South Texas Project
Units 3 and 4
Docket Nos. 52-012 and 52-013
Revised Response to Request for Additional Information

Attachment: RAI 12.02-20, Revision 2

RAI 12.02-20**QUESTION:**

Figure 12B-1 Spent Fuel Pool Analytical Model

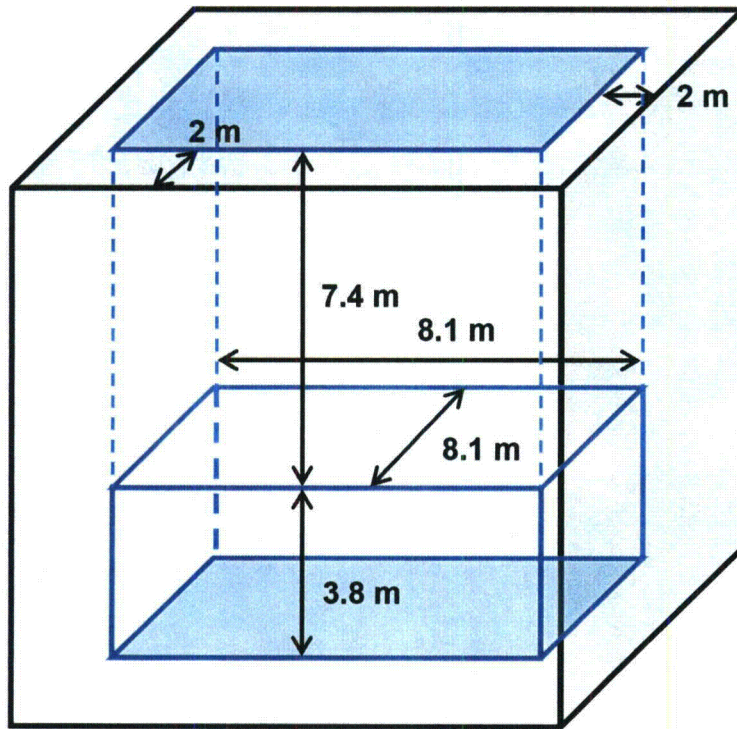
2. A figure was included in the RAI response showing a vertical cut view of the SFP. Some of the dimensions on the figure appear to be inconsistent with the spent fuel storage shielding dimensions shown in Table 12.2-5c of the ABWR DCD and STP 3&4 FSAR. In addition, this figure does not include some of the dimensions and spatial relationships needed by the staff to perform a shielding calculation. Specifically, there appears to be an inconsistency between the depth of water above the fuel assemblies as shown in the SFP figure and the depth of water as indicated in Table 12.2-5c. In addition, the figure does not show the minimum distance between the top of a raised fuel assembly at maximum height and the SFP water surface, the height of the SFP fuel pool bridge above the water surface, and the location of refueling personnel during refueling operations on the fuel pool bridge. In order for the staff to be able to perform an accurate deep dose equivalent calculation for a person standing on the fuel pool bridge, please provide an updated figure of the SFP, addressing these items.

Figure 12B-1 in the previous RAI response showed the preliminary spent fuel pool rack layout. The dimensional data on that figure were not used in any calculations. Figure 12B-1 has been replaced with a sketch of the analytical model used in the calculations showing the critical dimensions.

Figure 12B-3 Maximum Single Bundle Dose Rate at Refueling Platform

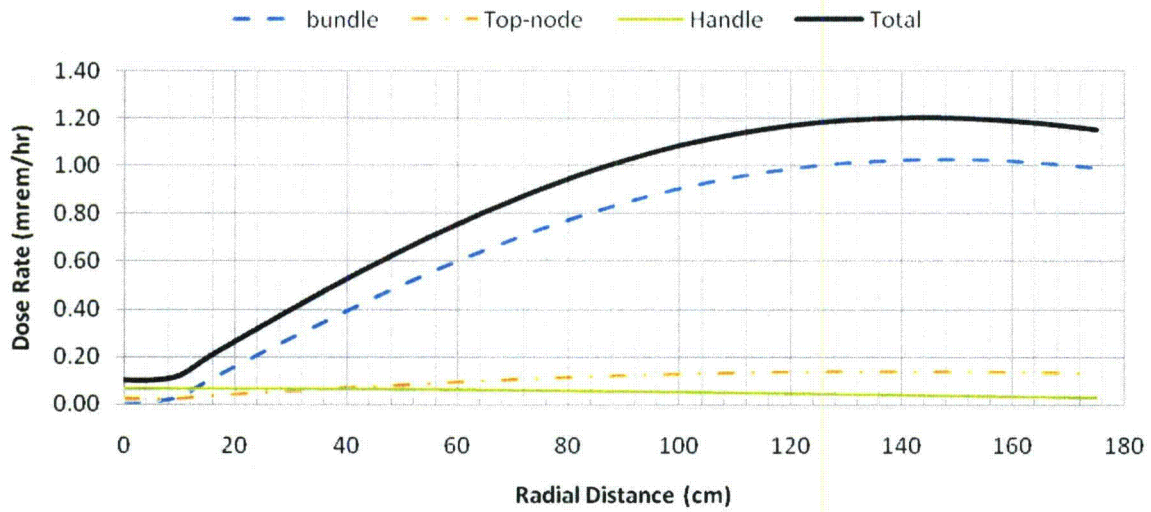
3. As stated in the response to 1. above, additional information is needed in order to perform a radiation dose calculation for workers standing on the fuel handling bridge. During refueling operation ANSI/ANS-57.1-1992 states that fuel handling equipment shall be designed so that the operator will not be exposed to >2.5 mrem/hr (25 μ Sv/hr) from an irradiated fuel unit, control component, or both, elevated to the up-position interlock with the pool at normal operating water level. Verify that the maximum dose rate to an operator on the fuel handling bridge will not exceed the 2.5 mrem/hr criteria stated in this ANSI/ANS standard.

It is assumed that the fuel assembly is lifted to a height of 8.5 ft (2.6 m) below the pool water surface with the operator on the refueling machine trolley platform at a minimum of 8.8 ft (2.7 m) above the water surface. The resulting peak dose rate at 8.8 ft (2.7 m) above the water surface is approximately 1.2 mRem/hr, located at a radial distance from the fuel assembly of approximately 140 cm (4.6 ft) as shown in Figure 12B-3. Even when the maximum fuel pool water source (see Section 12B.5 below) is added, the dose rate

remains below 2.5 mRem/hr. For an operator standing on the trolley platform, the dose rate will be less than that shown in Figure 12B-3; therefore the design criteria of ANSI/ANS-57.1-1992 has been satisfied.
